Service Bulletin

PRELIMINARY INFORMATION

Subject: Gauge Fluctuation, Various DTCs, Wiring Harness Chafing/Rubbing on A/C Line

Models: 2011-2013 Chevrolet Silverado
2011-2013 GMC Sierra
Equipped with 6.6L Duramax™ Diesel Engine (RPO LML)

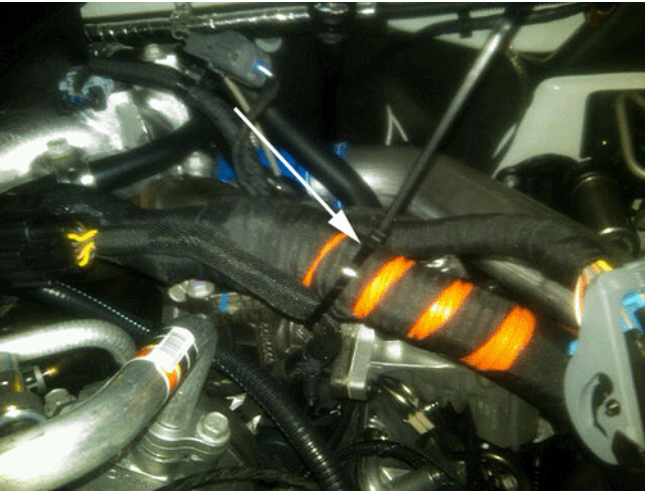
The engine wiring harness may be rubbing on the A/C line.

Repair the wiring harness and install a tie strap to the area shown above.

Refer to SI for wiring repairs.
